RECEIPT DATE: 9/18/24 **ONSITE SEWAGE DISPOSAL SYSTEM** P 587810

APPROVAL DATE: 1/29/25 **PERMIT: NEW CONSTRUCTION** A \_\_\_\_\_

PROPERTY ADDRESS: 11079 Gaither Farm Road

**From:** Silvast, Zackary  
**Sent:** Wednesday, January 15, 2025 3:41 PM  
**To:** Luke Groom  
**Cc:** Wellen, Jennifer; Burns, Matthew; Page, Shepsura  
**Subject:** regarding 11079 Gaither Farm Road (lot 15) septic changes  
**Attachments:** 11079 Gaither Farm Road (Lot 15) as-built.pdf

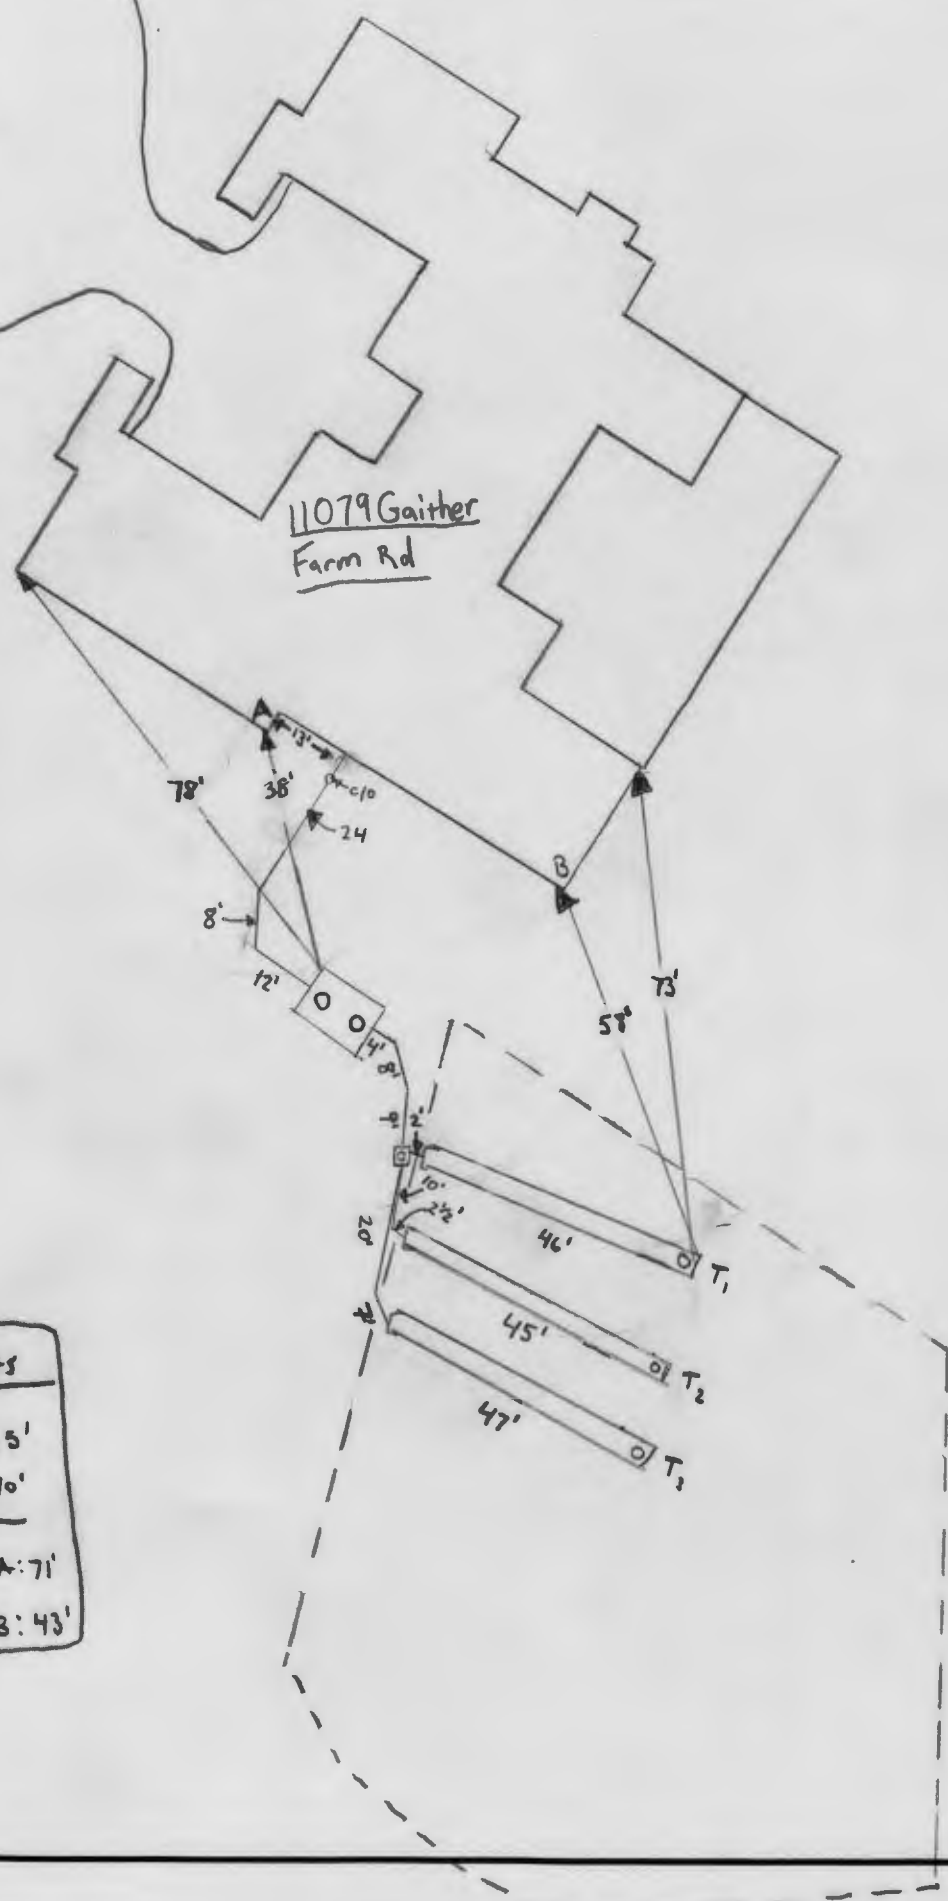
12/26/24 Contractor completed the front line. Sch. 40 pipe used. Pipe is bedded with 57 stone. C/O installed 5' from house. Baffles installed in ST. OK to backfill (MB)

diff in front plan. Installer wants to move tank slightly so that's less levels in front line & outlet in line with upper septic trench. D-box also moved in front of upper trench. STA & trenches existed, some fit on site creating trench beginning to move down 9' & end up 13' moved down 5'. Will not impact rest of system.

12/19/24 Contractor has trench #1 and #2 dug. Trench #2 has been backfilled with the end left open. Top of stone to grade is about 3.5'. Geotextile fabric added and absorption pipe added OK to backfill trench. Trench #1 bottom is per plan. Bottom of pipe is 4'. Contractor will leave front of trench open for tomorrow. Tank will be arriving on Monday at 10am. (MB) 12/20/24 Contractor installed d-box and lines running into trenches. Stoning the back line with 57 stone. Trench 3 has been dug. Top of stone is 3.5'. Geotextile fabric laid. D-box is level and has a baffle. OK to backfill trench 3 and pipe leading to trenches. Contractor to leave d-box open till Monday. Plans to dig the septic tank hole tomorrow (Saturday) (MB) 12/23/24 Contractor has septic tank installed and leveled. Completed back line to d-box bedding the overdig with 57 stone from ST to d-box. D-box is leveled. OK to backfill (MB) 1/29/25 Marc Hereth is now registered with MPE (MB)

Measurements  
D-box - B: 45'  
D-box - A: 70'

T<sub>1</sub> beginning - A: 71'  
T<sub>1</sub> beginning - B: 43'
